Plan & Architectural Review Meeting

Monday, September 09, 2024 - 6:00 PM

- [2.](#) Discussion and possible approval of a Conditional Use Permit and Site Plan Review for a multifamily development located on vacant land at the corner of Moraine View Parkway and Jakes Way Tax Parcel # /WPB 00044.

To: Taylor Zeinert, Economic Development Director
From: Dan Meyer, Police Chief 
RE: Review of Moraine View Parkway and Jakes Way Site Plan
Date: July 22, 2024

SITE GRADING PLAN C2.0

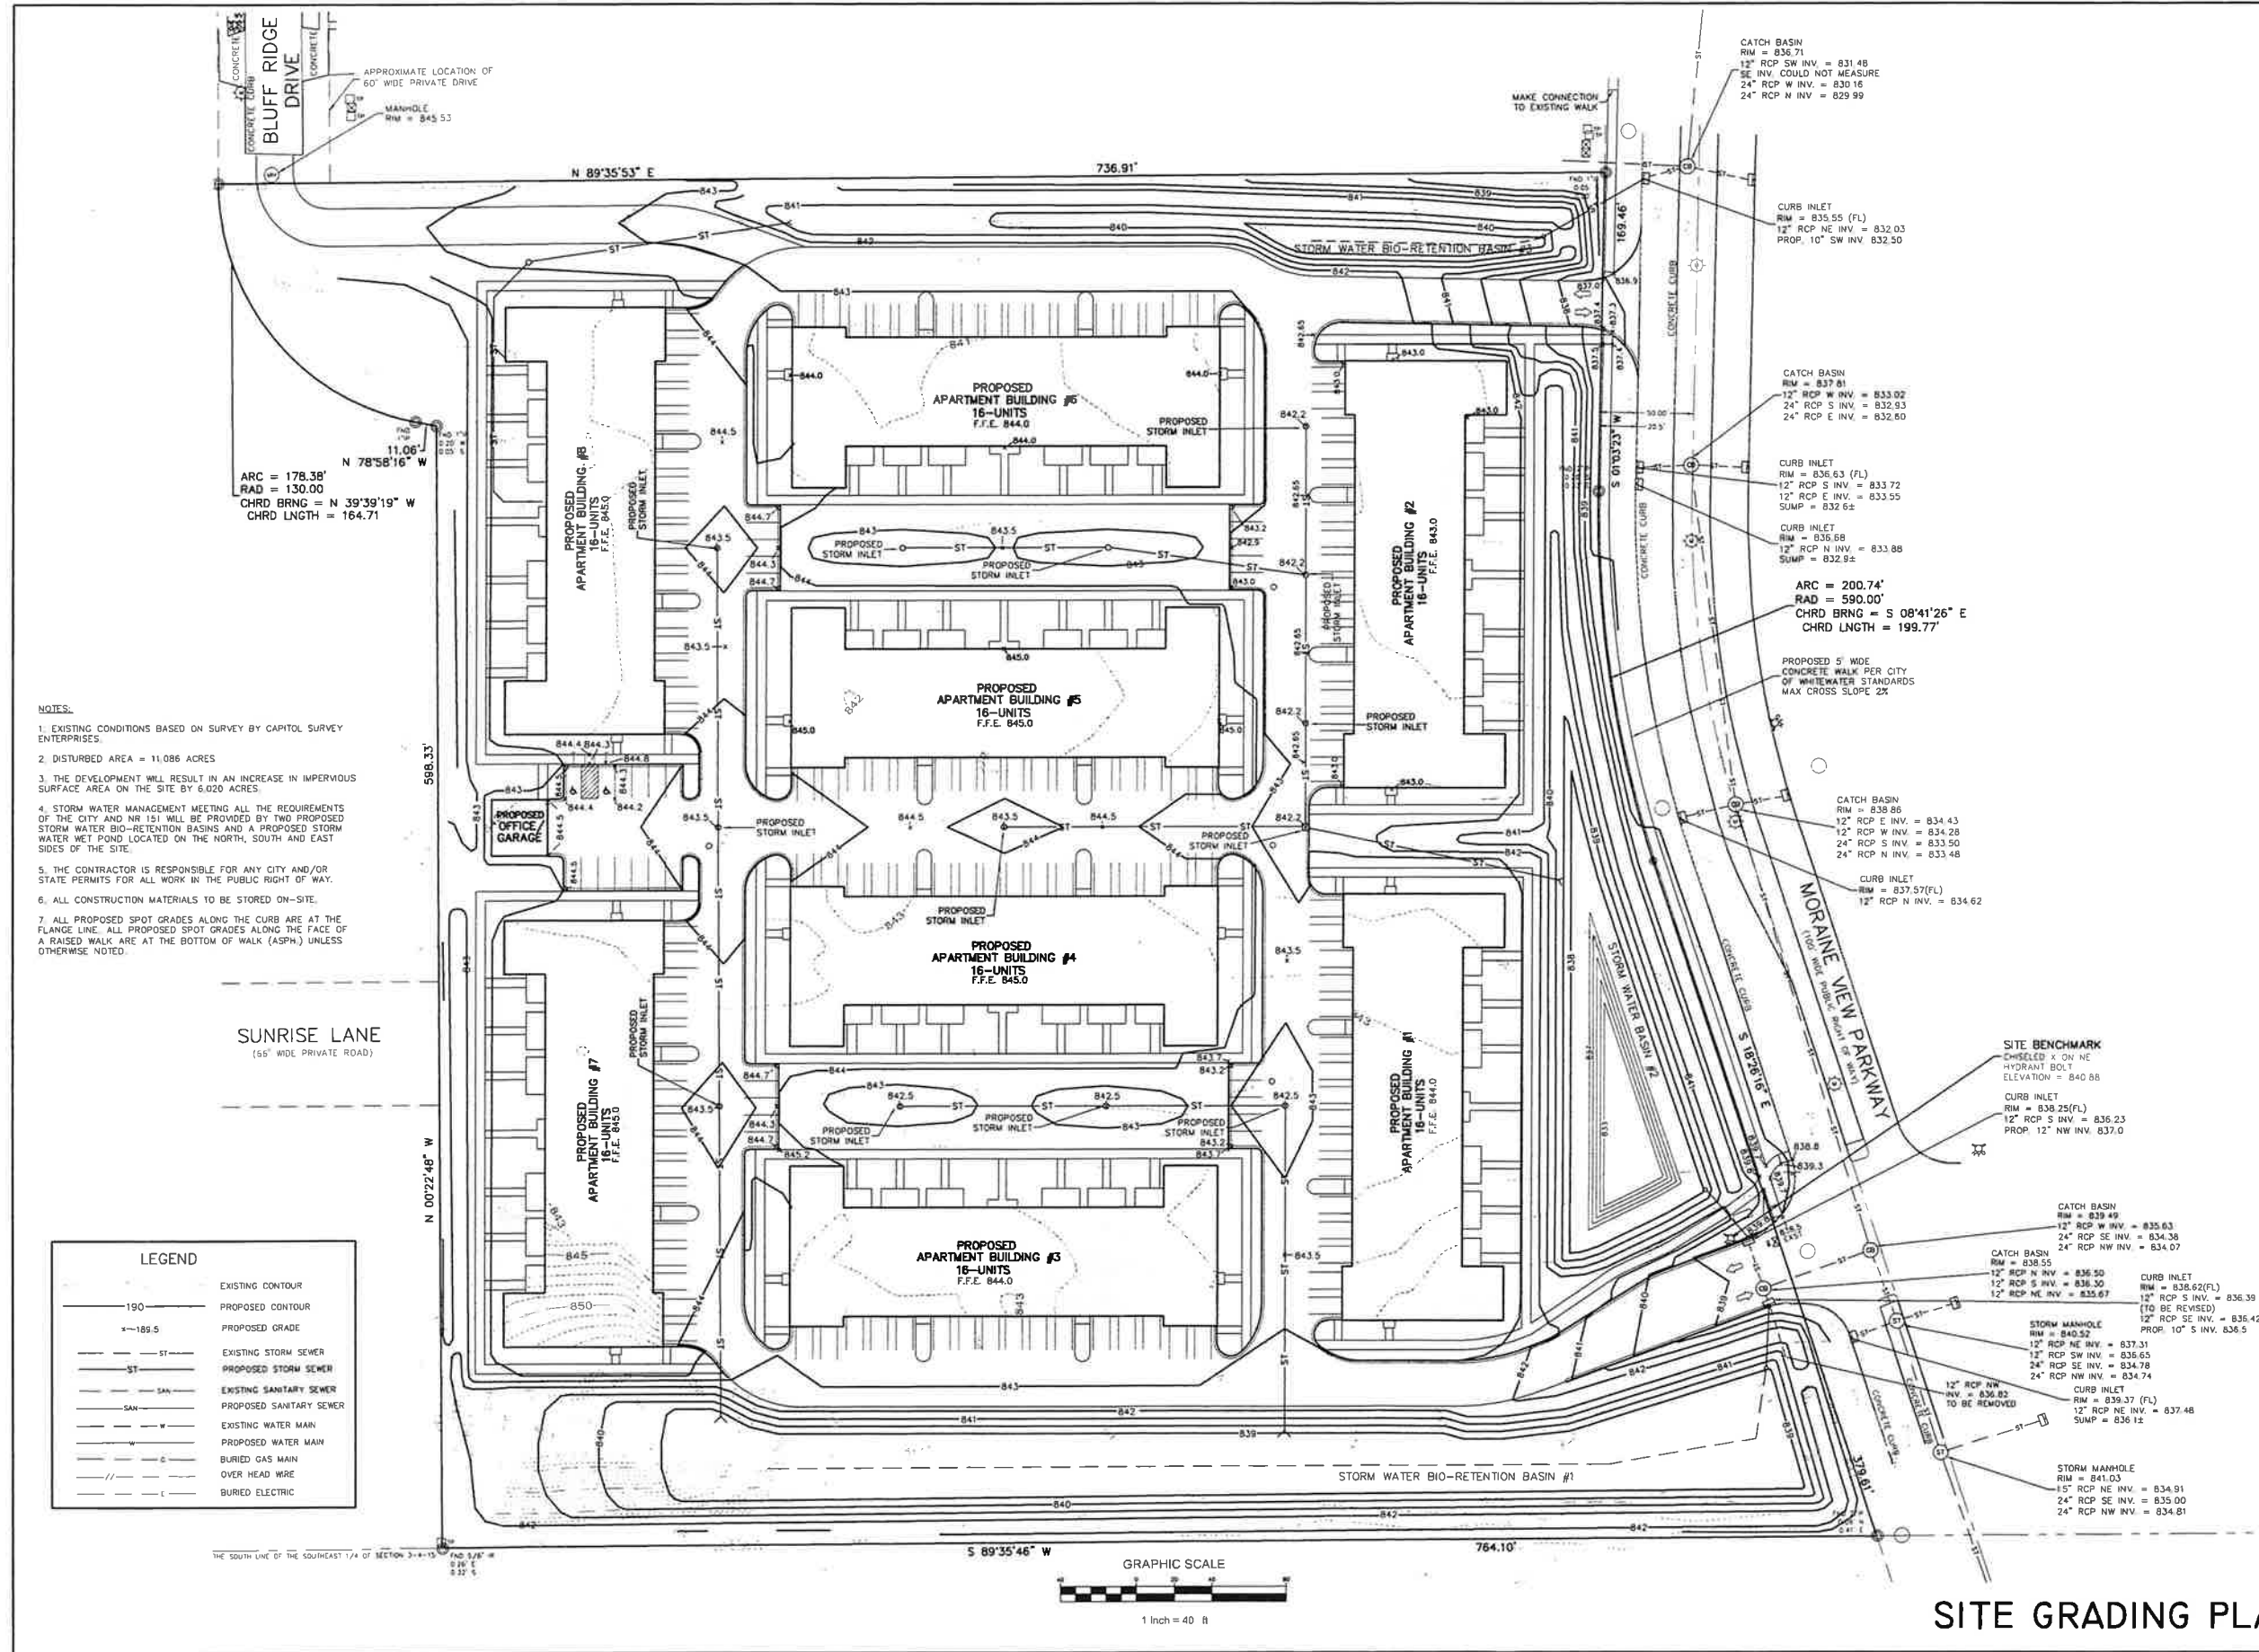
Site Access: While the current plan includes two ingress/egress points off of Moraine View, which meet the required width per code, we believe that extending Bluff Ridge Drive to the south would enhance emergency vehicle access. This third avenue of approach would facilitate efficient operations and provide an additional route for our apparatus.

Turning Radius: We have noted some challenges for our larger apparatus to make the turn near buildings 1 and 2 upon entering the development. To address this, we suggest widening the main approaches or adjusting the curb/walkways by a few feet. Similarly, adjustments at the entrances for garage access to buildings 4 and 5 would improve accessibility. We believe these modifications can be easily discussed and implemented with the developer.
